E5071C-06

S E R V I C E N O T E

E5071C ENA Series Network Analyzer, 9 kHz to 20 GHz

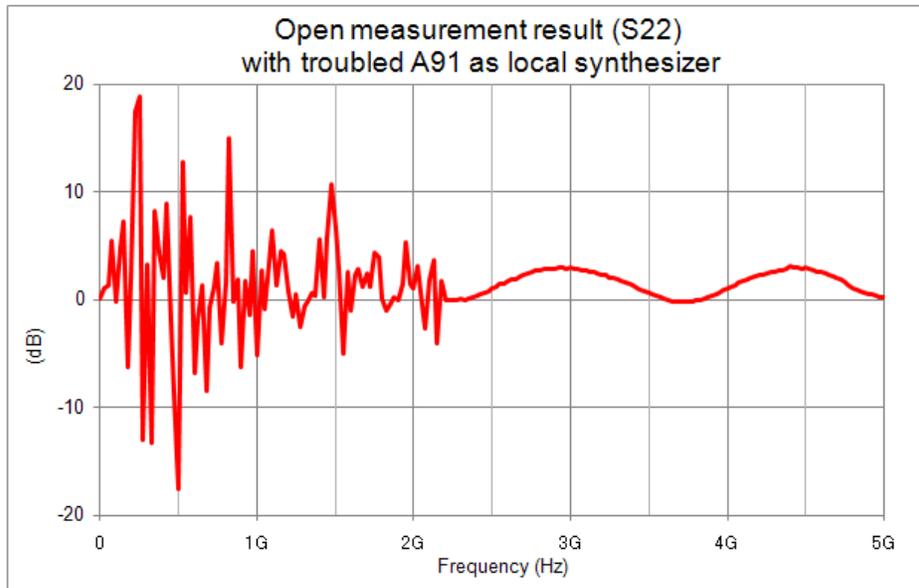
Shortly after turning on the E5071C and then “Preset” key pressed, the S11 is fine. But when the E5071C operator changes stop frequency to 6G, 6.5G, 7G etc., the S11 trace shows strange spur at 68M to 2.1G. (The stop freq point varies around 4.39G to 7.0G)

The same symptom occurs on S22, S33 and S44.

The below is a sample failure symptom on S22.
